#PIT5756: Various Electrical Concerns (Inspect UBEC Bolts For Being Loose) - (Jun 26, 2020)

Subject: Various Electrical Concerns (Inspect UBEC Bolts For Being Loose)

Brand:	Model:	Model Year:		VIN:		Engine:	Transmission:
		from	to	from	to		
Chevrolet	Silverado 1500 (New Model)	2019		All	All	All	All
Chevrolet	Silverado	2020		All	All	All	All
GMC	Sierra 1500 (New Model)	2019		All	All	All	All
GMC	Sierra	2020		All	All	All	All

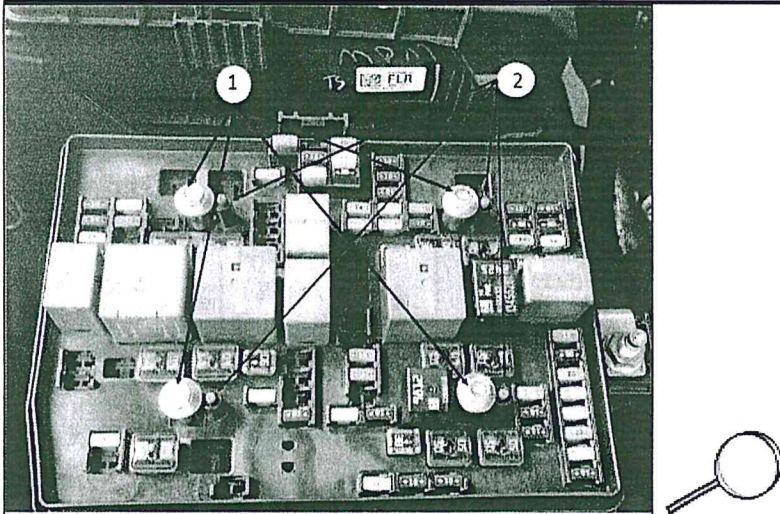
These concerns could be caused by the X50A Underhood Fuse Block bolts (1), shown below, being loose. The X50A has built in indicators (2), which pop up as the X50A bolts are tightened down, to indicate that the X50A is fully installed. In some cases, even if these green indicators (2) are popped up, the bolts (1) may still be loose.

Inspect the X50A Underhood Fuse Block bolts (1) and verify they are properly torqued to 53 lb in (6Nm).
